SERVICE BULLETIN

Inspection, Check and Replacement of Hook
Assembly P/Ns 505960-401 and 502737-459

SB505960-01, Issue: 4
Page: 1 of 13
Date: 12-Jul-2018

Page(s)	Correction/Update
All	Complete revision to clarify content, incorporate FAA comments and prepare the service bulletin for an FAA airworthiness directive.

Figure 1 – Hook Assembly Without Exposed Springs

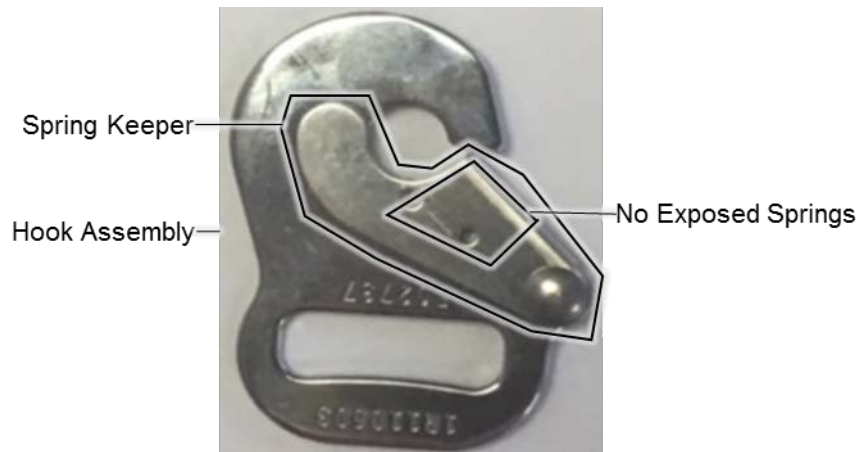
RC Step 2. Find the hook assembly (Figure 1 and Figure 2 on the connector half and the buckle half.

Step a. If the hook assembly on the connector half and the buckle half does not have exposed springs (Figure 1) you are done with this service bulletin.

Step b. If the hook assembly has exposed springs (Figure 2) proceed with this service bulletin.

Hook assemblies with exposed springs are subject to damage (e.g. compressed springs, bends or rotation or deformation).

Restraints without exposed springs (Figure 1) weigh 6 grams more than restraints with exposed springs (Figure 2).

This service bulletin ensures hook assemblies do not have exposed springs providing the criteria and instruction to identify and replace restraints.

Figure 3 – Damaged Hook Assembly

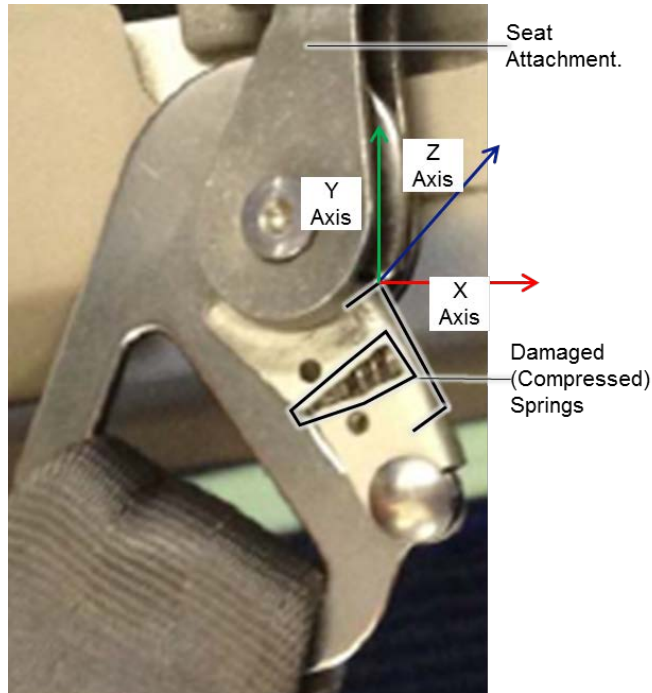
RC Step 2. Visually examine the hook assembly for damage (e.g., compressed springs, bends, rotation or deformation of the bridge along the X axis, Y axis or Z axis) that would restrict movement or function (Figure 3 and Figure 4).

Step a. If there is no evidence of damage the visual inspection is complete. Perform a functional check following the procedure in section 3.3.

Step b. If there is evidence of damage a functional check is not required.

Step i. Return the restraint to AmSafe by following the instructions in the material – price and availability section of this service bulletin and by following the instructions in the shipping and handling instructions in the ICA or CMM.

Step ii. Upon receipt of a new restraint from AmSafe, install the new restraint following the instructions in the ICA or CMM.

Figure 5 – Spring Keeper and Closed Loop

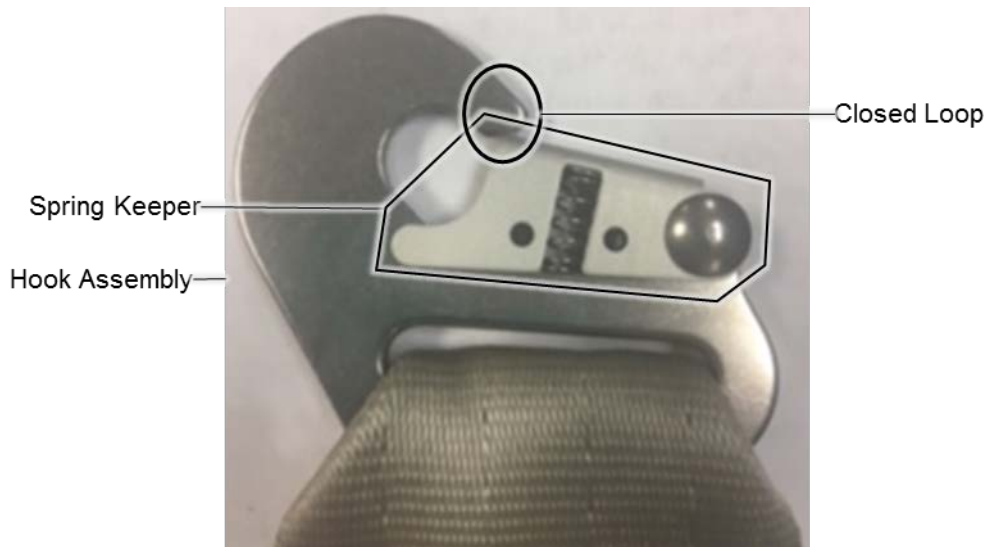
Step b. The spring keeper should return to a closed position. The closed position is achieved when the spring is firmly engaged/pressed and the keeper is against the hook, creating “closed loop” (Figure 5). There should be no deformation or damage preventing the spring keeper from returning to a closed position.

- Step c. If the spring keeper easily compresses and releases and returns to the closed position the functional check is complete.
- Step d. If the spring keeper does not easily compress and release, or the spring keeper does not return to a closed position, return the restraint to AmSafe.
- Step i. Return the restraint to AmSafe by following the instructions in the material – price and availability section of this service bulletin and by following the shipping and handling instructions in the ICA or CMM.
- Step ii. Upon receipt of a new restraint from AmSafe, install the new restraint following the instructions in the ICA or CMM.
